JOHNSON COUNTY, KANSAS
CBOC
SFO VA-101-15-N-0098
Clarifications Round #1

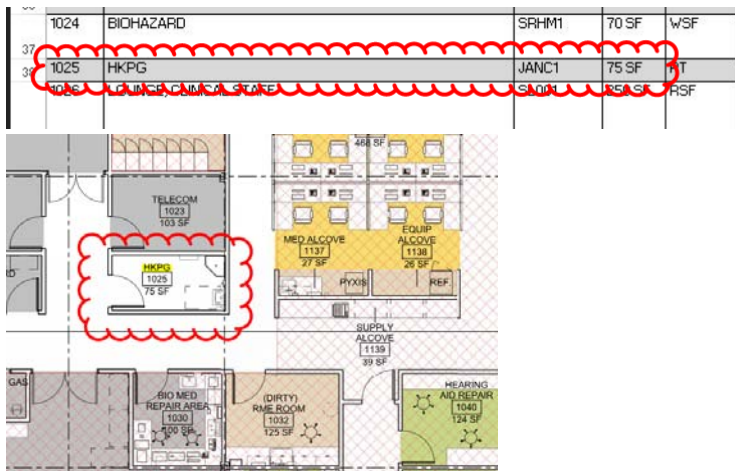
5. Sheet A0101: The floor plan notes 22,910 NUSF. But the hatch area on the CAD drawings is 25,283 SF. Please verify that.

RESPONSE: See SFO Amendment No. 1 Part IX Concept Plans Revised A0101.
